# 1989 - 1991 Corvette: Service Bulletin: No/Delayed Reverse When Cold

**Subject:** NO/DELAYED REVERSE WHEN COLD INSTALL REV.  
INPUT CLUTCH SEAL

**Bulletin Number:** 91-493-7A - (03/11/1992)

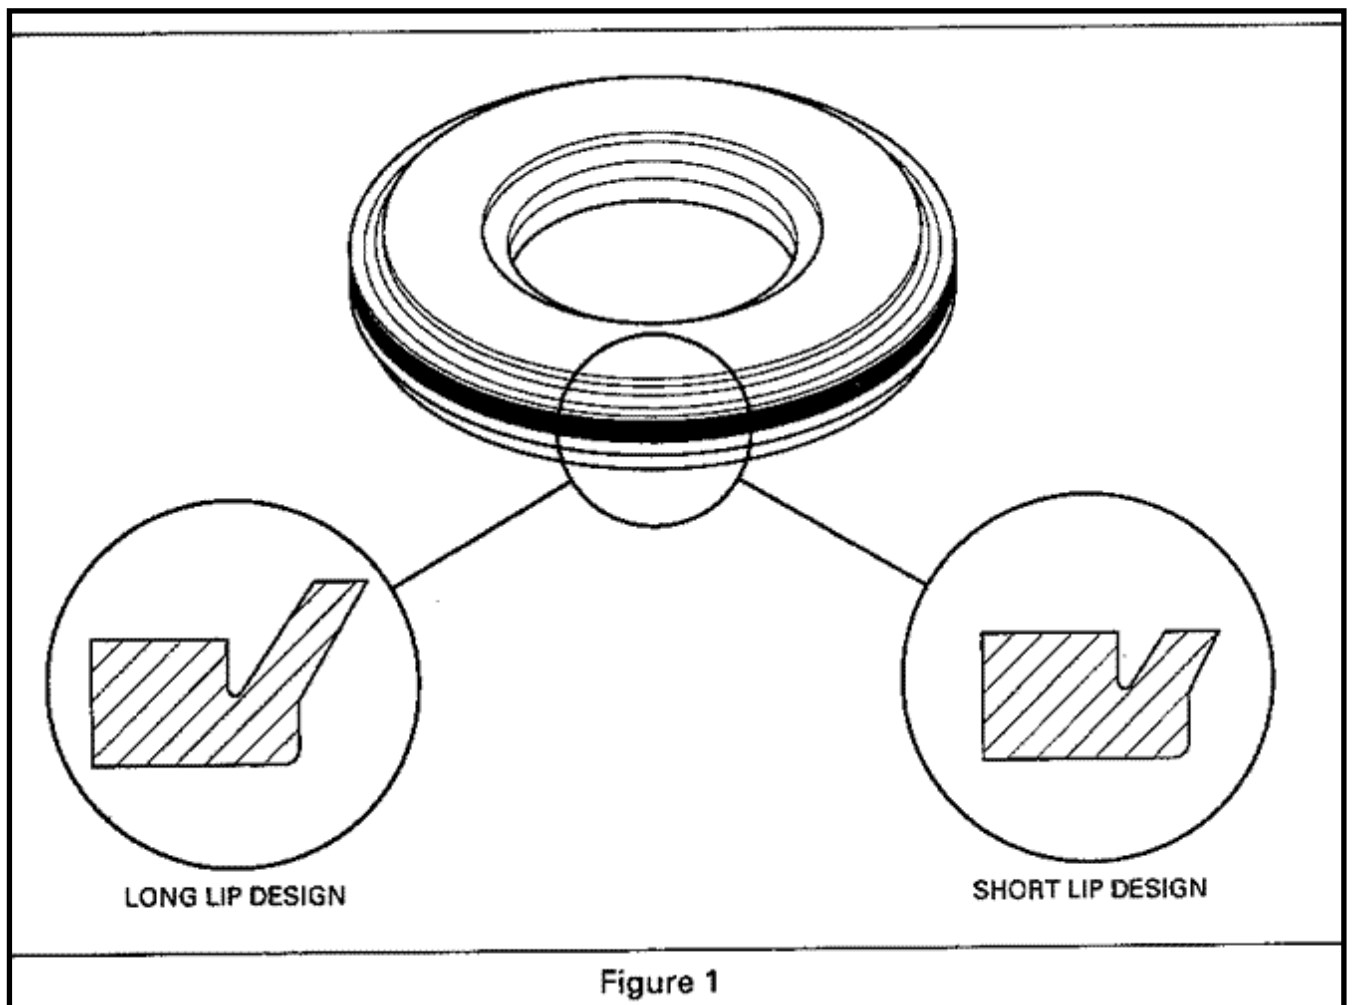
If a transmission has a 'no reverse' or 'delayed reverse' condition, inspect the reverse input clutch piston outer seal. Determine if the seal is a 'short lip' or 'long lip' design by comparing it to Figure 1. If it is a short lip design, replace it with a long lip seal contained in the service packages listed under Service Parts Information.

If the reverse input clutch piston outer seal is a long lip design, or the newly installed long lip seal doesn't alleviate the delayed reverse condition, the reverse input clutch housing may be out of round. Inspect the housing and replace if necessary.
